County of San Mateo RFP Maple St Correctional Center Photovoltaic System

ADDENDUM No. 05
	San Mateo County 555 Government Center, Fifth Floor Redwood City, CA 94063
	RFP: Maple St Correctional Center Photovoltaic System
	Date: February 15, 2023

ADDENDUM 05

TO	All Plan Holders	ISSUE DATE	15 February 2023
		PROJECT #	21-001
REGARDING	Correctional Facility Solar Shade Structure	NARRATIVE PAGES	2
		SPECIFICATION PAGES	-
DISTRICT	San Mateo County	DRAWING SHEETS	4
		REFERENCE SHEETS	14
		TOTAL PAGES	20

1 ENLARGED LIGHTING SITE PLAN
E2.3 SCALE: 1/8" = 1'-0"

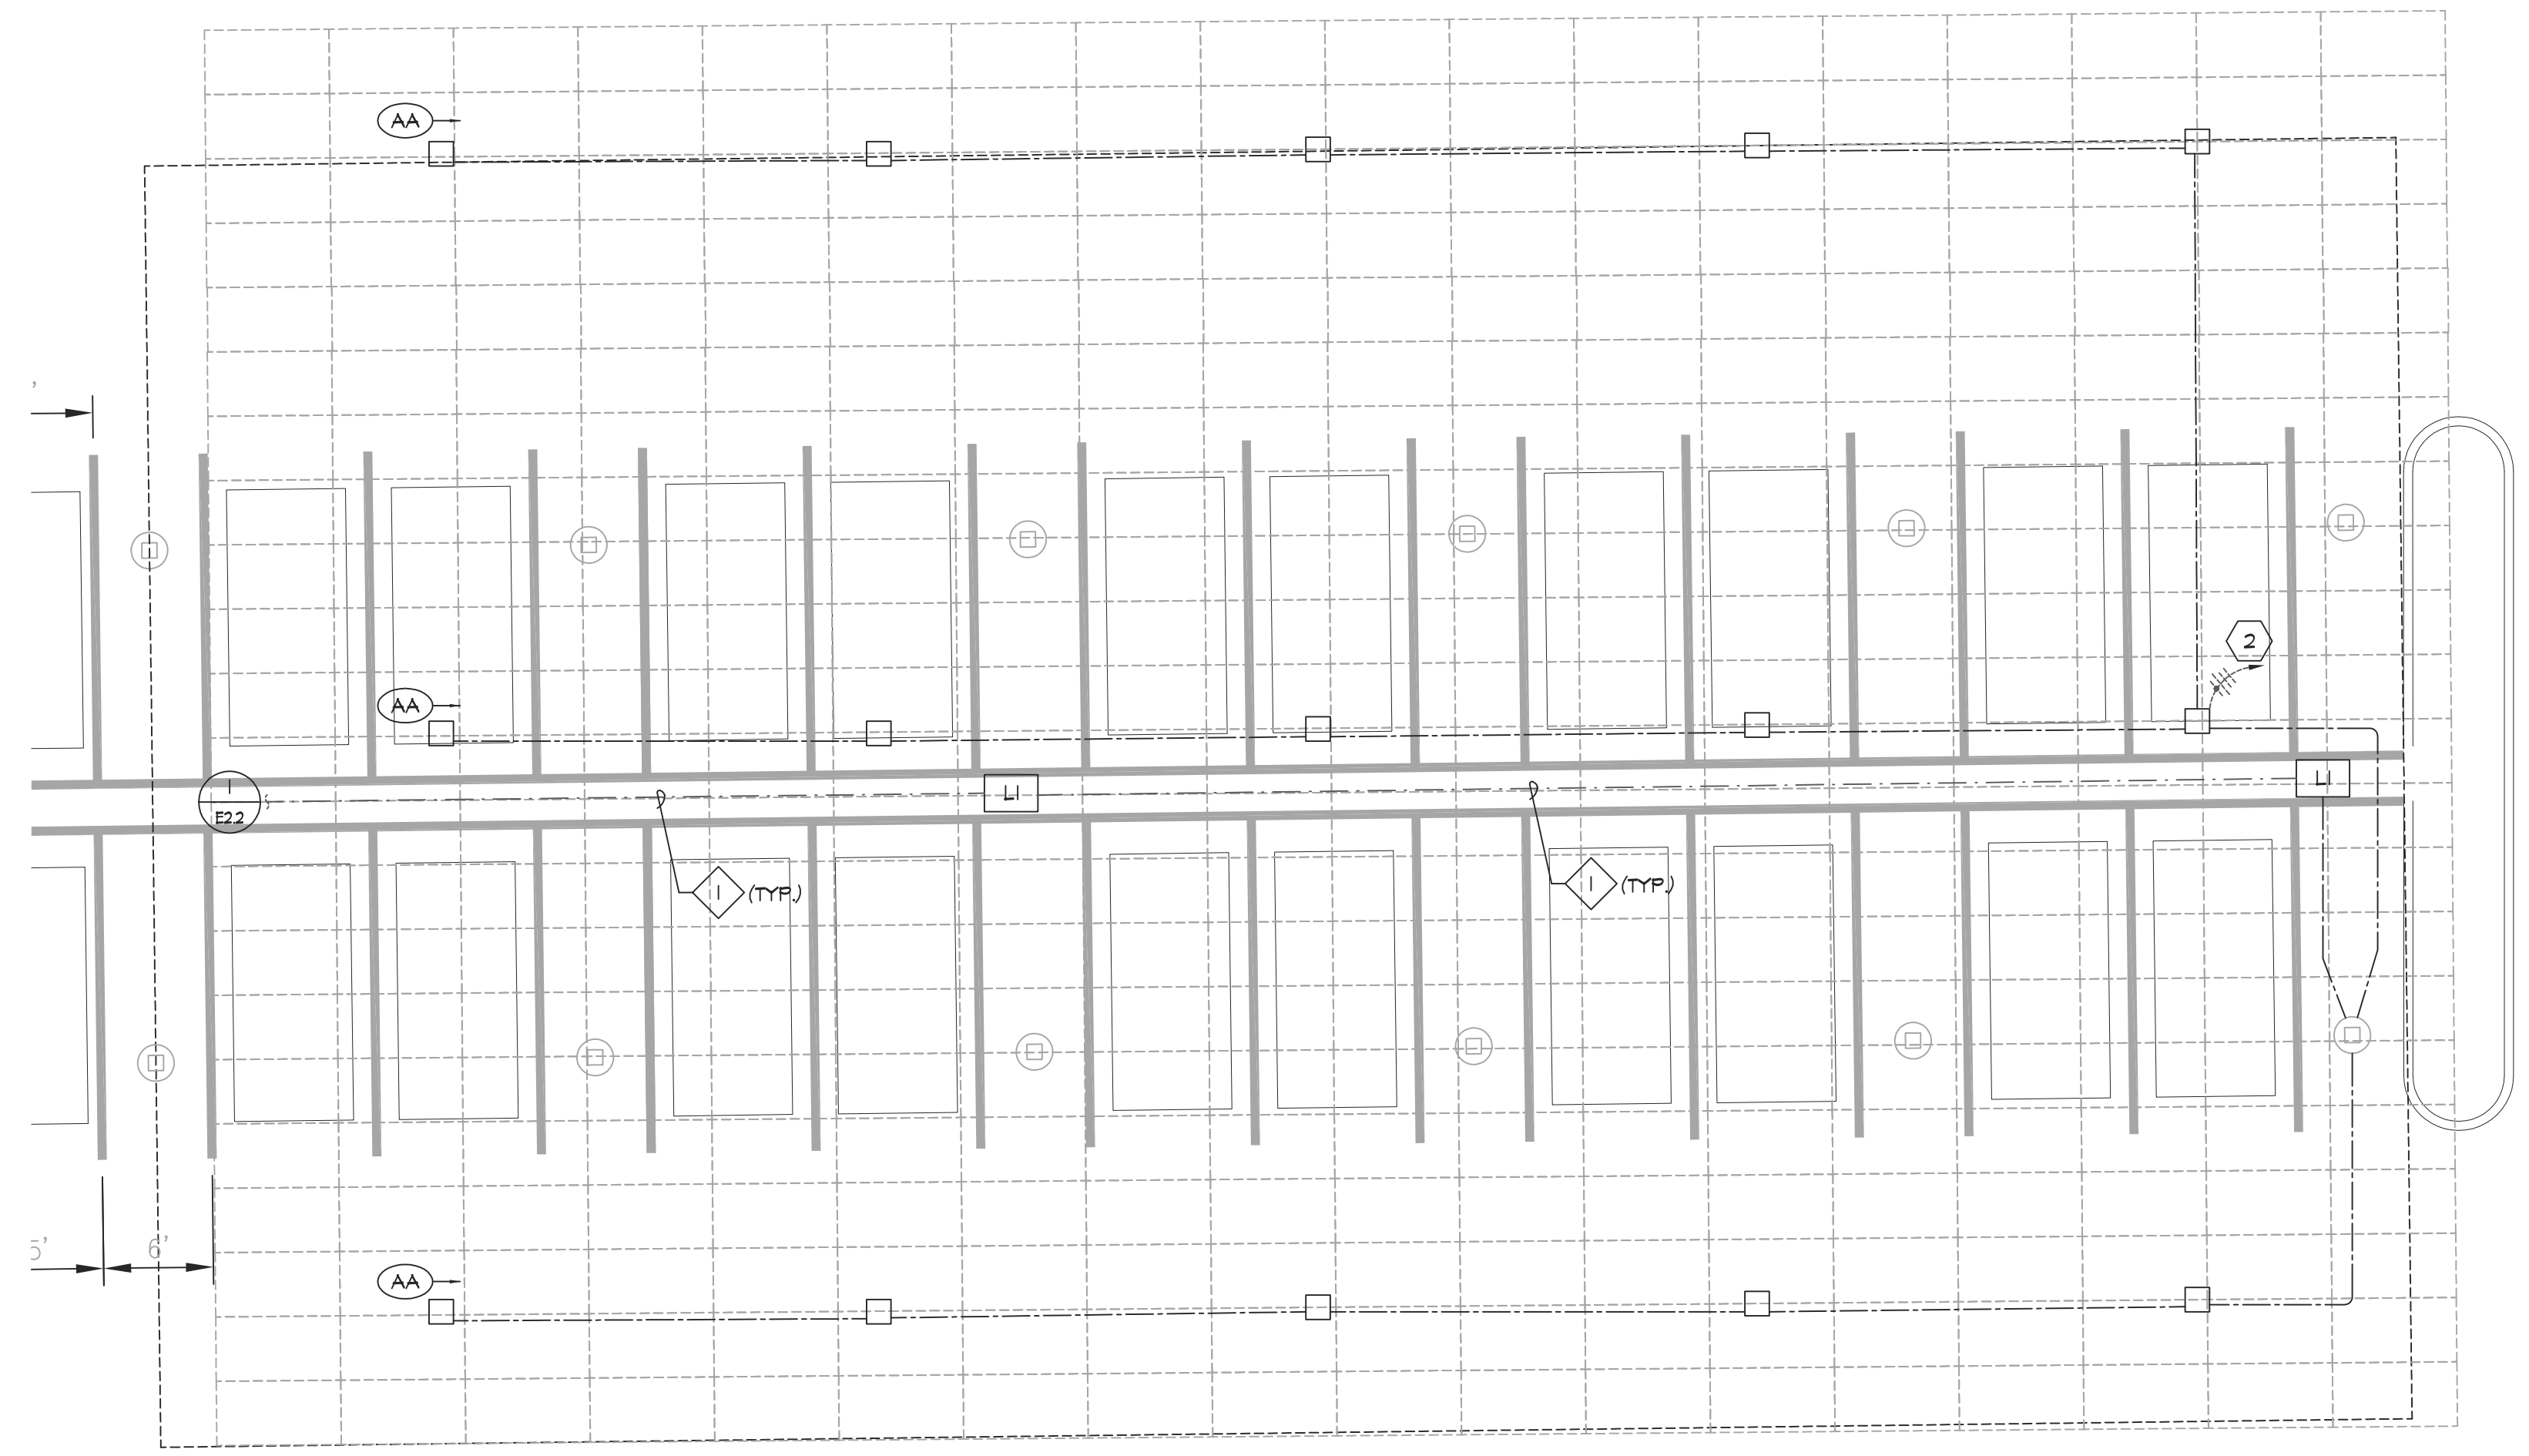
Canopy lighting

- See attached addendum drawings E- 2.1, 2.2, 2.3 for canopy lighting
